eGrabber

Flash EEPROM Change Note

1629 Coaxlink Duo PCIe/104-EMB
1633 Coaxlink Quad G3
1633-LH Coaxlink Quad G3 LH

1634 Coaxlink Duo PCIe/104-MIL
1635 Coaxlink Quad G3 DF
1637 Coaxlink Quad 3D-LLE

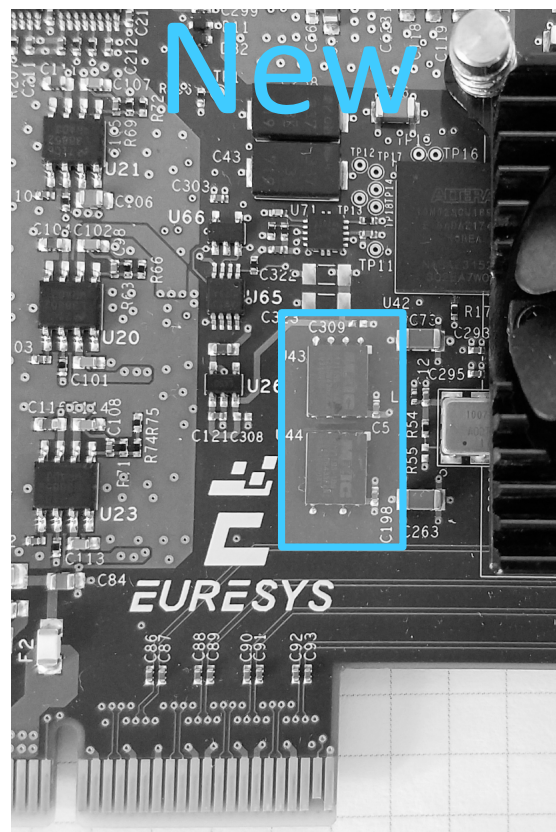
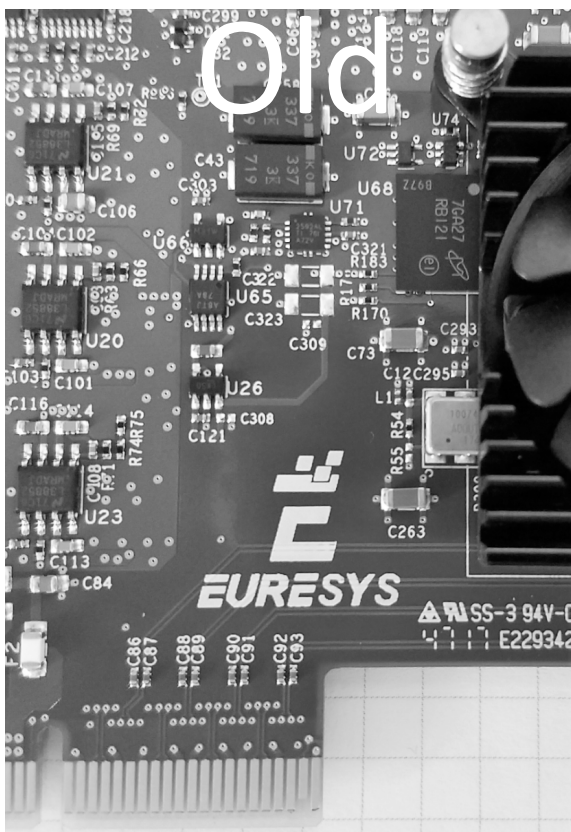
New 1633 Coaxlink Quad G3, 1633-LH Coaxlink Quad G3 LH and 1637 Coaxlink Quad 3D-LLE can be visually identified by the two SPI Flash Memory IC's located between the fan and the PCI Express connector.

See the blue rectangle in the following drawing:
